# Access Compliance Report

## Public Rights-of-Way

Intersection ID: 22758	Main Street: RIDGE_OAK_DR	Cross Street: MOSS_RD	Location: SW
ADA ID: D46A3F95C209	Ramp Type: Perp	Initial Pass/Fail: Fail	Overall Compliance: No
Severity Score: 8.75			
Codes/Mitigation Info/Possible Solution		Field Measurements/Component Compliance

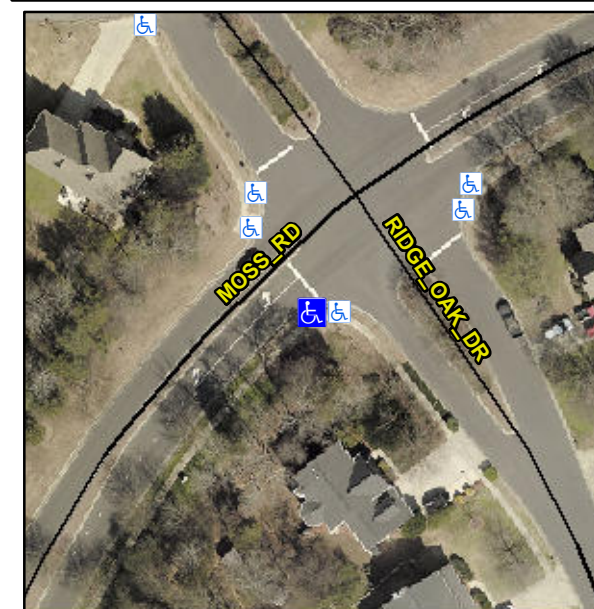
**Not Found, R304.5.1**

Compliance	Description	Data	Compliance	Description	Data
N/A	Ramp Length (in)	99.0	Yes	Ramp Slope (%)	5.9
No	Ramp Width (in)	39.0	Yes	Ramp XSlope (%)	0.5
N/A	Flare Type LT	N/A	N/A	Flare Type RT	N/A
N/A	Flare Slope LT (%)	N/A	N/A	Flare Slope RT (%)	N/A
N/A	Flare Traversable LT?	N/A	N/A	Flare Traversable RT?	N/A
N/A	Landing Length (in)	N/A	N/A	DWS Provided?	N/A
N/A	Landing Width (in)	N/A	N/A	DWS Contrast?	N/A
N/A	Landing Slope (%)	N/A	N/A	DWS Length (in)	N/A
N/A	Landing X Slope (%)	N/A	N/A	DWS Full Width?	N/A
N/A	Landing Curb? (Y/N)	N/A	N/A	DWS Offset (in)	N/A
N/A	Shared Landing?	N/A			
N/A	Gutter Ponding?	N/A	N/A	Gutter Slope (%)	N/A
N/A	Gutter Lip Ht (in)	N/A	N/A	Gutter X Slope (%)	N/A
N/A	Painted X Walk1?	No	N/A	Painted X Walk2?	N/A
	X Walk 1 Direction	To NW		X Walk 2 Direction	N/A
N/A	X Walk 1 Width (in)	N/A	N/A	X Walk 2 Width (in)	N/A
	X Walk 1 Slope (%)	1.5		X Walk 2 Slope (%)	N/A
	X Walk 1 X Slope (%)	0.7		X Walk 2 X Slope (%)	N/A

**Remove & Replace Entire Ramp.**
